V series PCB Update, for appliances produced post 1 January 2004

Please be advised that an updated Printed Circuit Board (PCB) has been introduced on all V-series water heaters as of the 1 January 2004 production run.

Fig.1

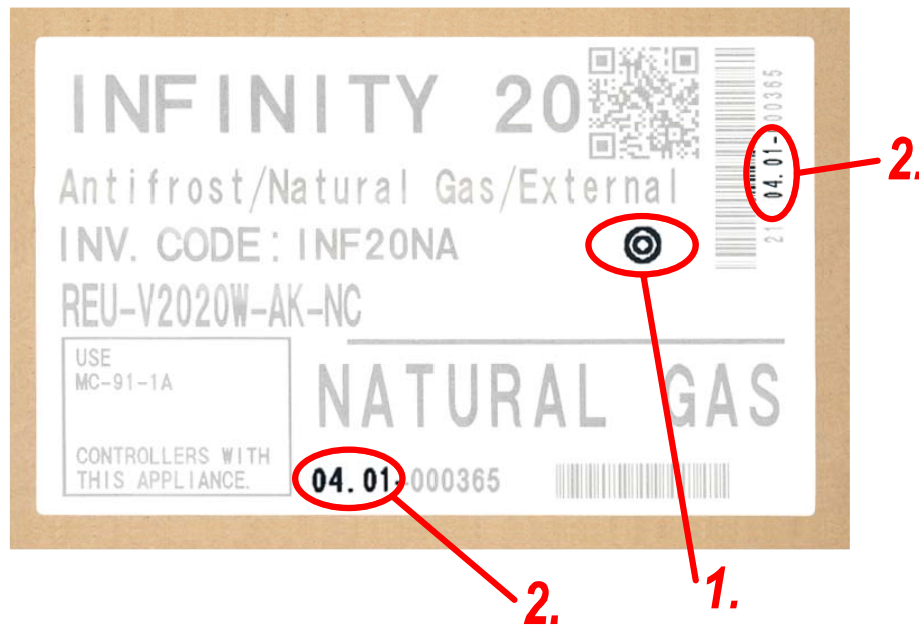
To identify cartons containing updated appliances look for a double outlined circle (1. Fig.1) or appliance serial numbers that have production dates post 1 January 2004 eg. 04. 01-xxxxxx (2. Fig.1), the same serial numbers located on the appliance data plates may be used to identify unpacked appliances.

Fig.2

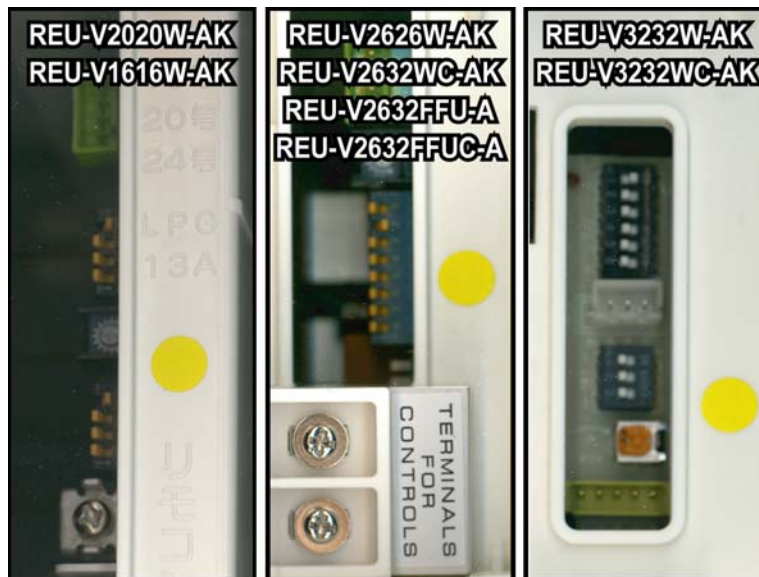
Spare part PCBs can be identified by a yellow dot on the side of the PCB assembly as shown in Fig.2.
